Serial: NPD-NRC-2009-230
November 19, 2009

**SHEARON HARRIS NUCLEAR POWER PLANT, UNITS 2 AND 3
DOCKET NOS. 52-022 AND 52-023
SUPPLEMENT 2 TO RESPONSE TO REQUEST FOR ADDITIONAL INFORMATION LETTER
NO. 023 RELATED TO PROBABLE MAXIMUM FLOOD ON STREAMS AND RIVERS**

**Shearon Harris Nuclear Power Plant Units 2 and 3
Supplement 2 to Response to NRC Request for Additional Information Letter No. 023
Related to SRP Section 02.04.03 for the Combined License Application,
Dated September 26, 2008**

NRC RAI NUMBER: 02.04.03-4

Figure 5. Ratio of Wind Speed of any Duration, U_t to the 1-Hour Wind Speed U_{3600}

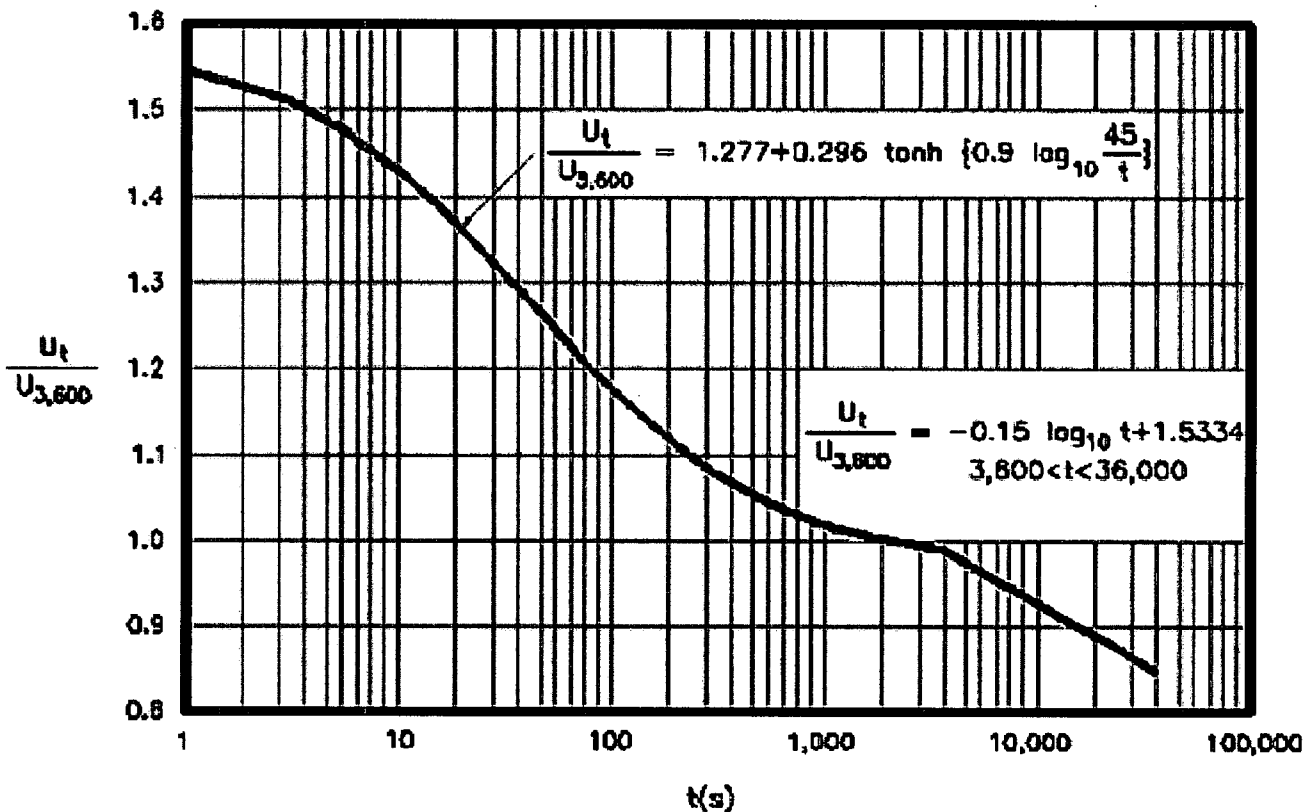
According to American National Standards Institute/American Nuclear Society (ANSI/ANS) 2.8-1992, the 2-year wind speed should be used while conducting the coincident wind-wave activity analysis. The 2-year wind speed at the HAR site is 50 miles per hour (mph). Before using this wind speed in the calculation of wave runup, several adjustments were applied following the procedure outlined in the *EM 1110-2-1100* (Part II) (USACE, 2006). The step-by-step procedure is as follows:

1. Standard measurements should be collected at 10 meters above ground surface. Since the wind speed obtained from ANSI/ANS 2.8.1992 was measured at 30 feet (about 10 meters) above ground, no adjustment needed to be applied.
2. Using the 2-year wind speed of 50 mph and Figure II-2-1 (Figure 5) of *EM 1110-2-1100* (Part II), the 1-hour wind speed was calculated as 50 mph.

The resulting averaging time interval, $t_{x,u}$ was then used in conjunction with Figure II-2-1 of *EM 1110-2-1100* (Part II) (**Figure 5**) in order to determine the appropriate wind speed for various locations. **Table 7** presents calculated corrections of wind averaging intervals for various fetch lines directed toward HAR 2, HAR 3, HNP, the Auxiliary Dam, and the Main Dam.

Figure 6. Ratio R_L of Wind Speed Overwater U_W to Wind Speed Overland U_L as a Function of Wind Speed Overland U_L (after Resio and Vincent [1977])

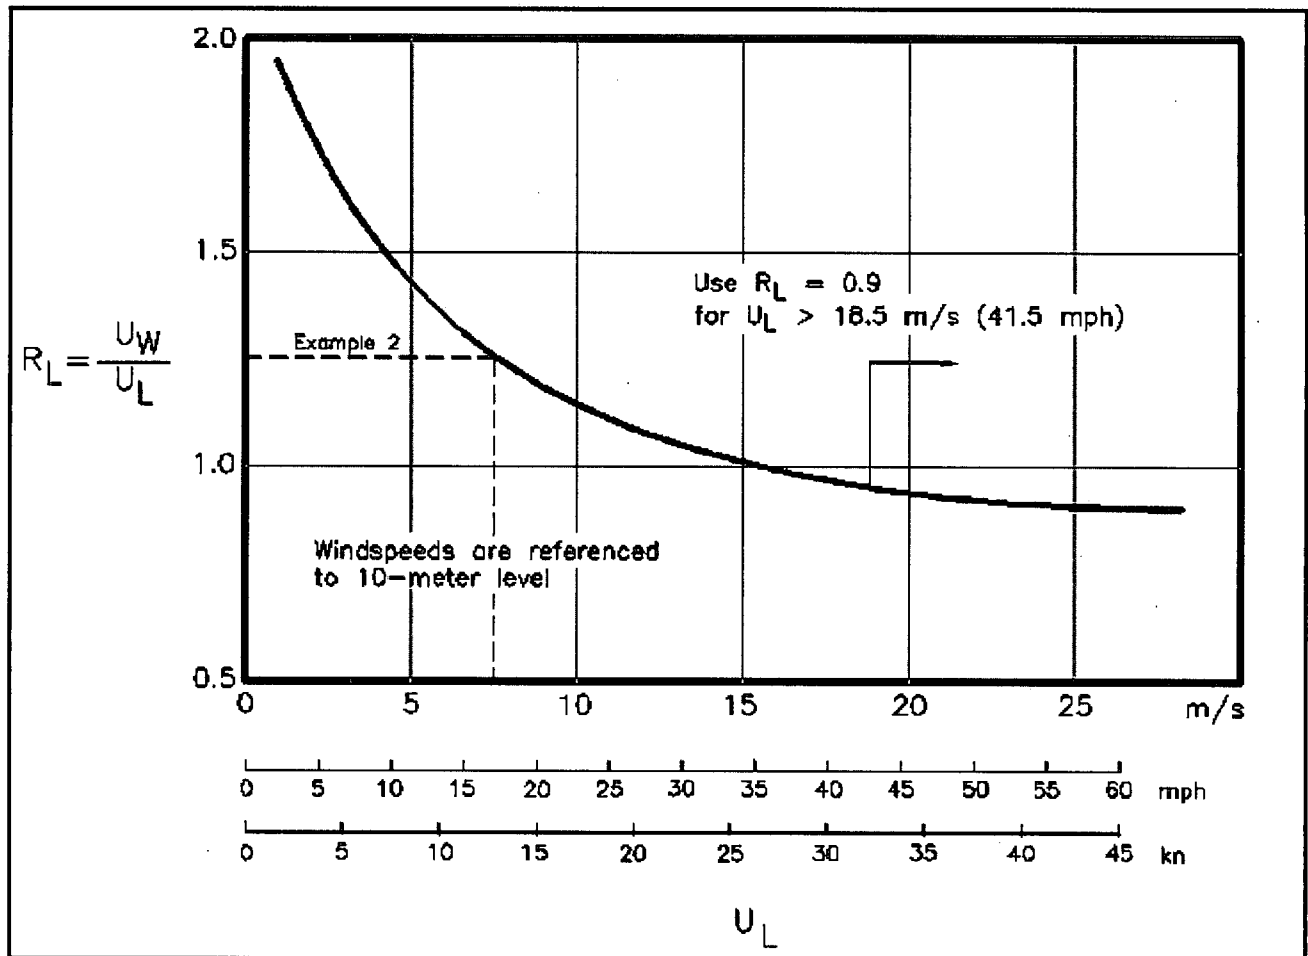
According to Figure II-2-7 (**Figure 6**), the correction factor R_L is given as follows:

R_L is a correction factor which is equal to 0.9 for $U_L > 41.5$ mph.

In this case, the overland wind speed, U_L , is 50.0 mph (22.4 meter per second [m/s]). As such, the correction factor, R_L , is equal to 0.9. However, in an effort to be conservative, a correction factor, R_L , equal to 1.0 was used for this analysis.

Figure 8. Fetch-Limited Wave Periods (Wind Speed in Increments of 2.5 m/s)

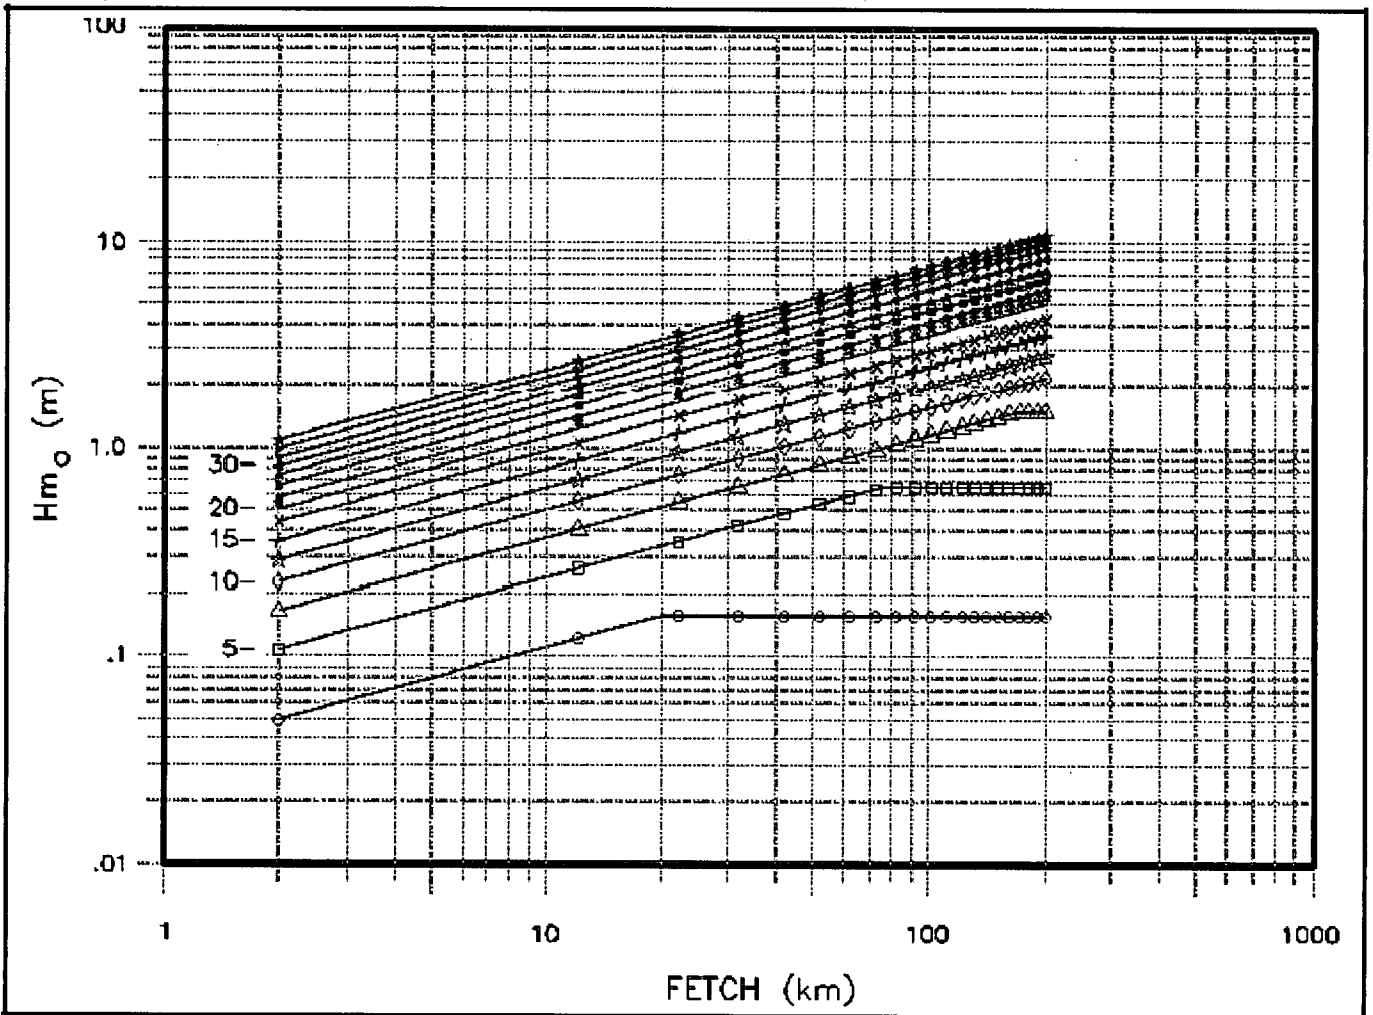
1. Using the previously determined fetch lengths and wind speeds, estimates of significant wave heights were obtained using the deepwater nomogram for the fetch limited wave heights given in the *EM 1110-2-1100* (Part II) (**Figure 7**).
2. Similarly, estimates of peak wave periods were obtained using the deepwater nomogram for the fetch limited wave periods given in the *EM 1110-2-1100* (Part II) (**Figure 8**).

FIGURE 2.4.3-209

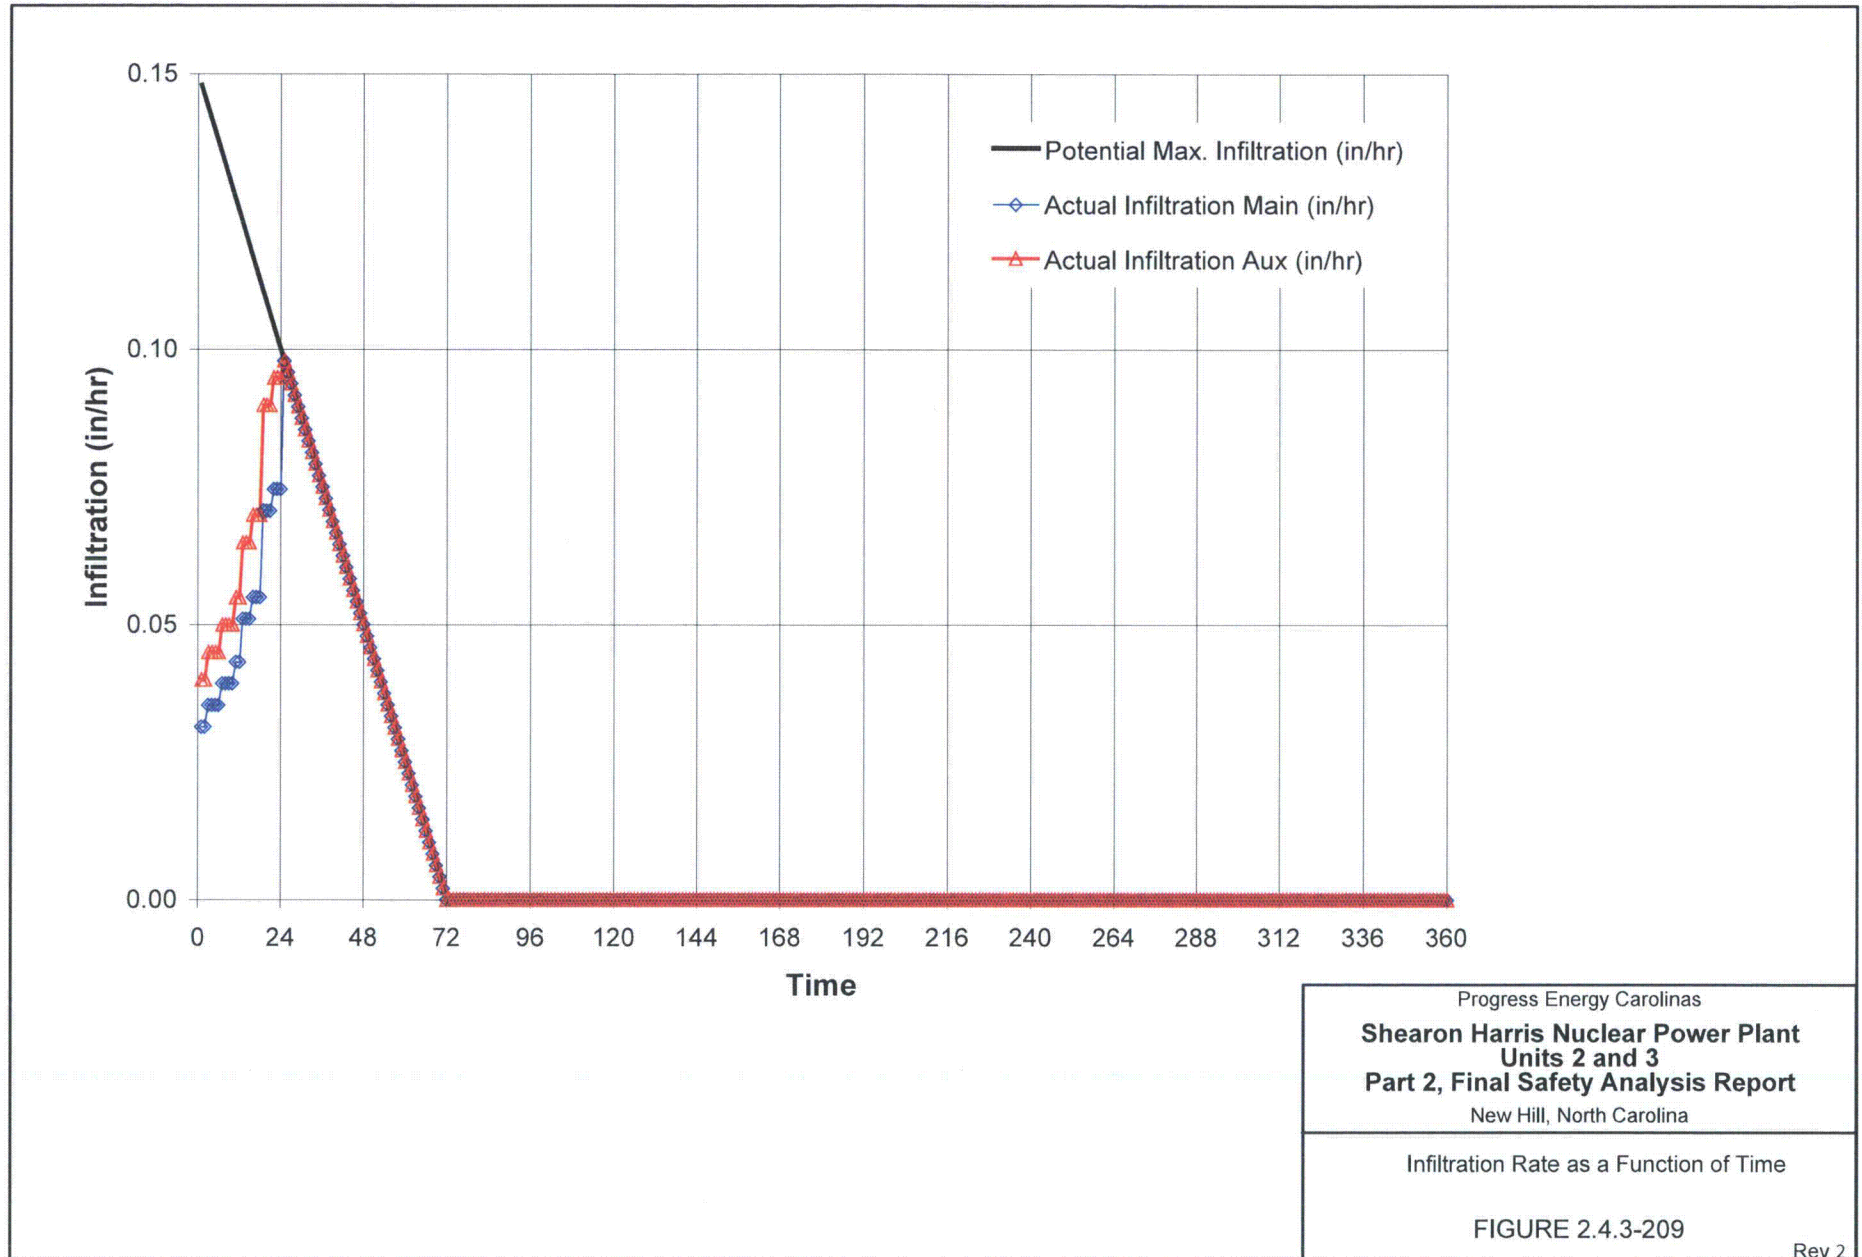
Figure 2.4.3-209 depicts the actual infiltration rate during the 72-hour antecedent storm and the two succeeding 72-hour periods of the PMP event for both the design storms associated with the Main Reservoir and the Auxiliary Reservoir drainage basins. It can be noted from Figure 2.4.3-209 that the actual infiltration rate is constrained only by precipitation levels for the first 24 hours of the antecedent storm. However, from hours 24 through 72, the infiltration rate is constrained by the potential maximum rate, as previously described. The infiltration rate is assumed to be zero after hour 72.

PMF Inflow in the Main Reservoir,
Peaking vs. No Peaking
FIGURE 2.4.3-216

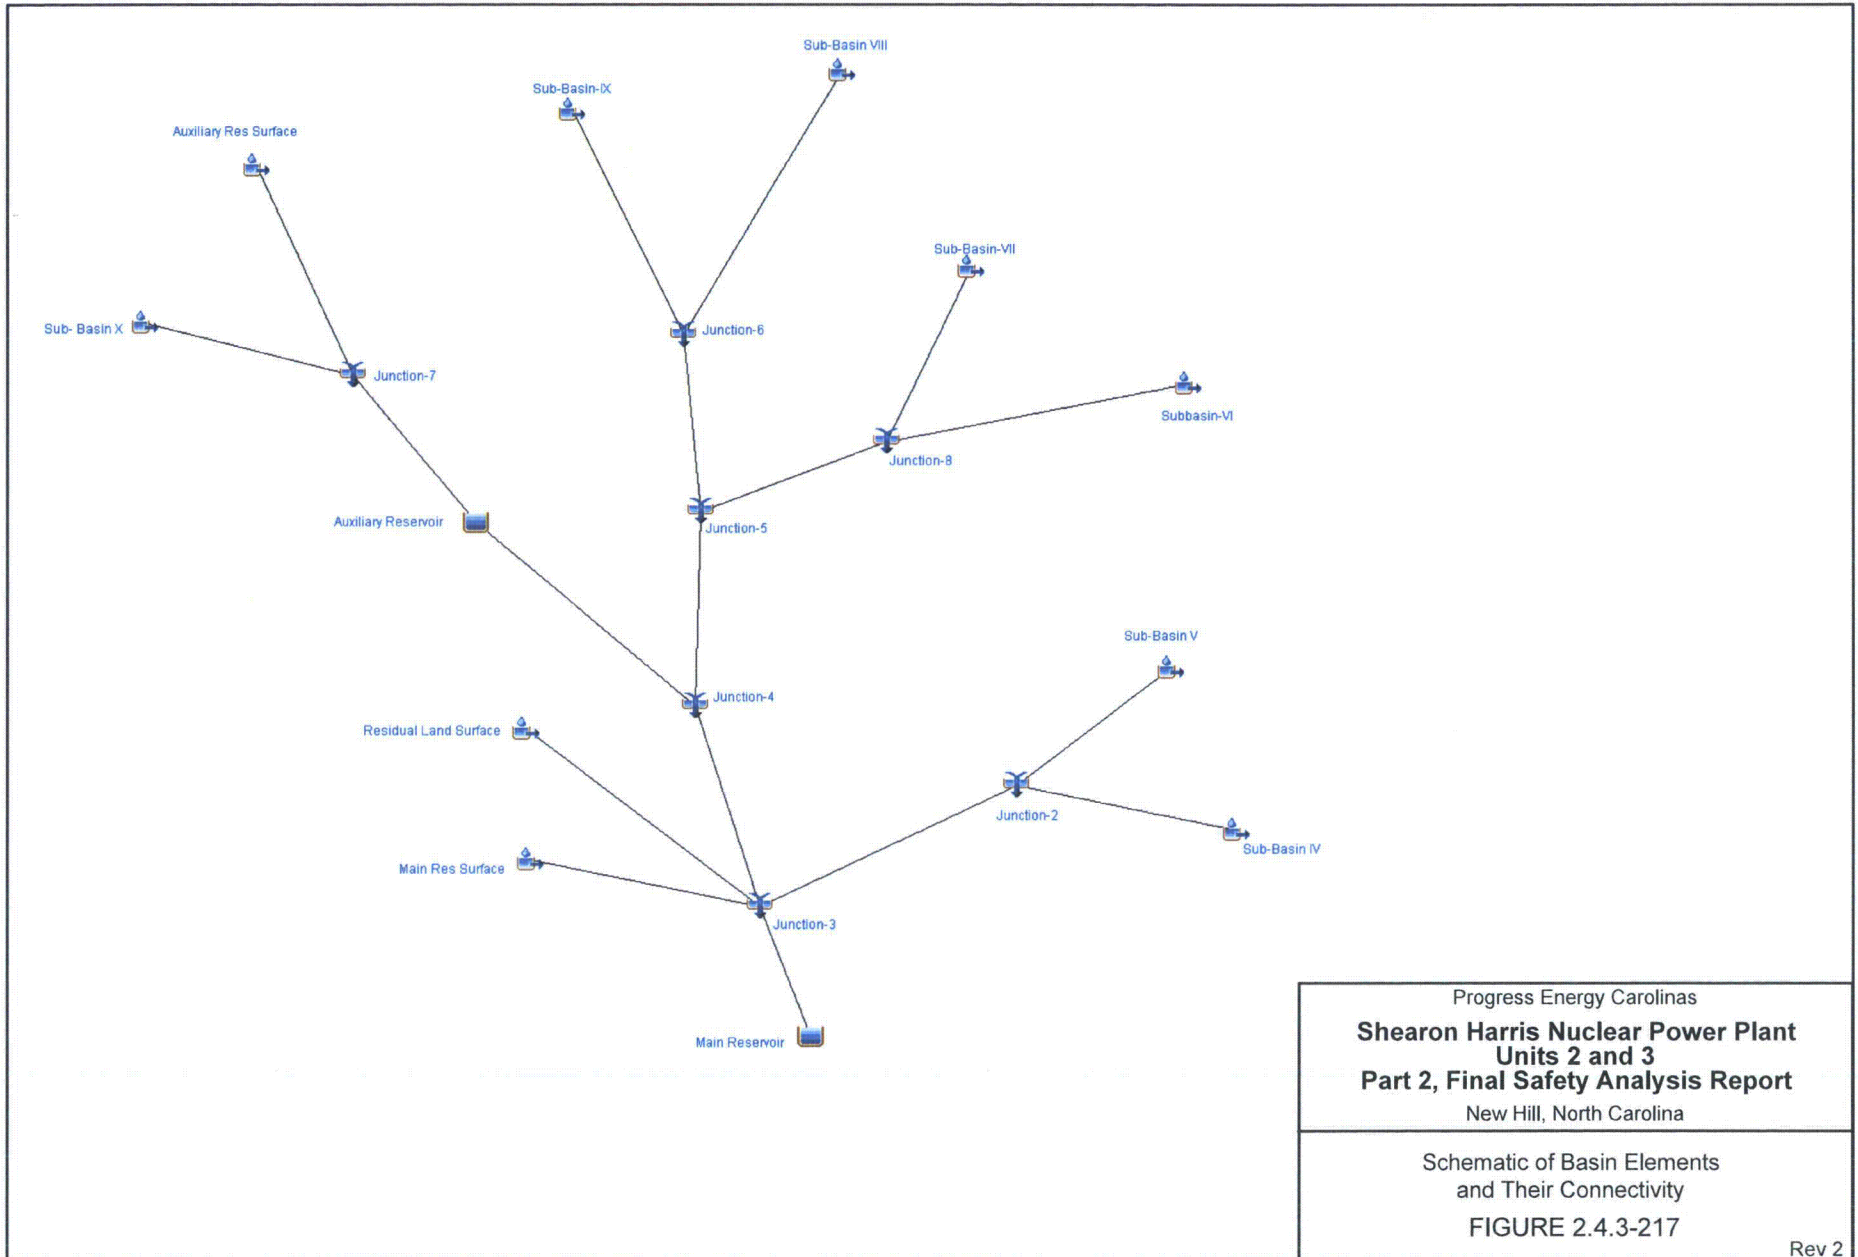
Using the PMP storms above the Main Dam (Figure 2.4.3-206) and Auxiliary Dam (Figure 2.4.3-208), along with the developed unit hydrographs for various sub-basins for both cases considering peaking and no peaking, inflow hydrographs to the Auxiliary and Main Reservoirs were determined using the HEC-HMS model. Figures 2.4.3-215 and 2.4.3-216 show inflow hydrographs to the Auxiliary and Main Reservoirs for both cases with and without considering hydrograph peaking. Table 2.4.3-224 provides a summary of inflow results for both the Auxiliary and Main Reservoirs considering 25 percent peaking and no peaking for the PMP event.
